**Heat and Control, Inc.
Packaging Service Department
Technical Bulletin PS TB62909**

TSC-RS

Belt Cover Replacement Procedure

Date: 06.29.09

Figure 4: Covers Removed

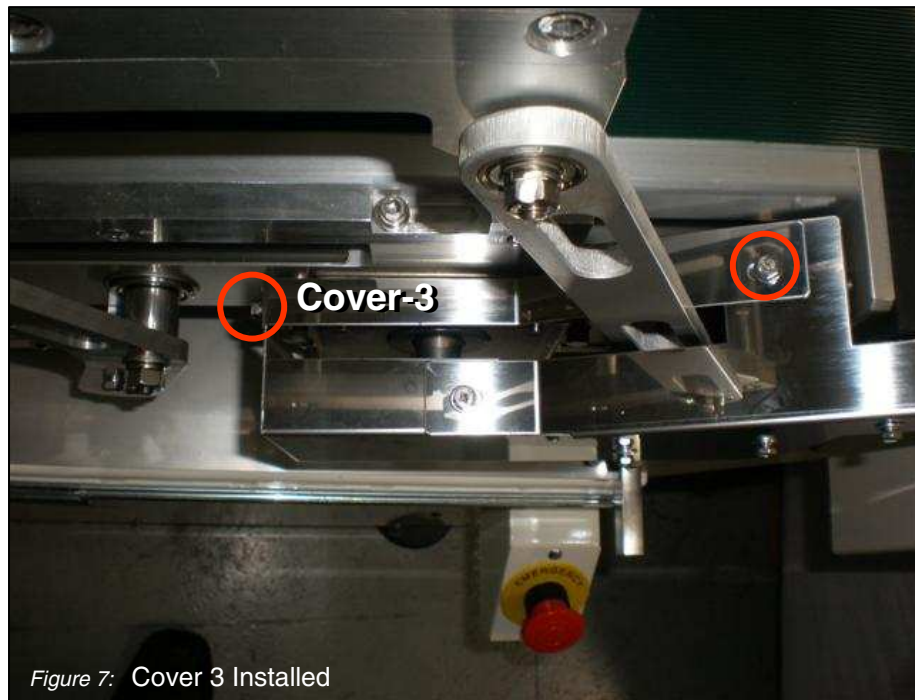
The excessive buildup of product inside the belt cover interferes with the operation of the TSC-RS.

The belt is revealed when covers have been removed.

Replace the existing cover with a new design making it more difficult for product to enter. Product that enters the cover will be able to escape via the open bottom.
